Loudoun County, Virginia

NOTICE TO BIDDERS

ADDENDUM NO. 2

RFQ 58772

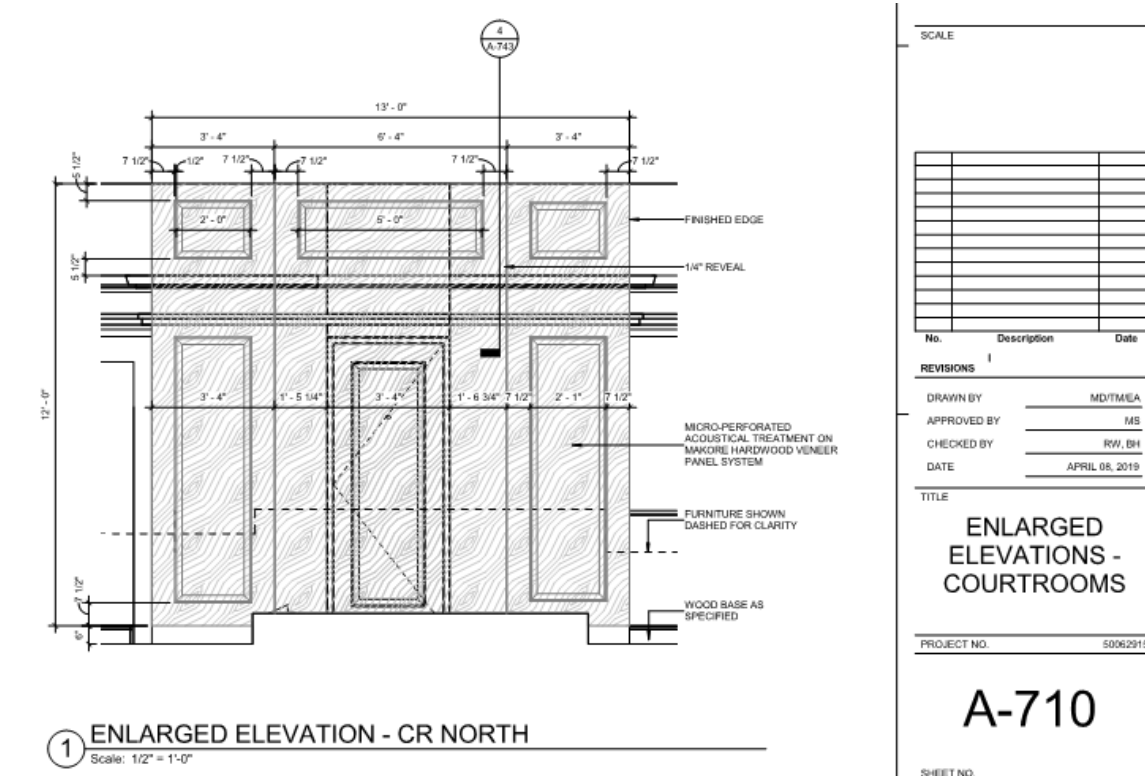
Q5: The Louver specification section 089119 calls for 8" wind driven but the detail on sheet A-615 shows 5". Please verify which depth is correct.

A5: The louver should be 5"
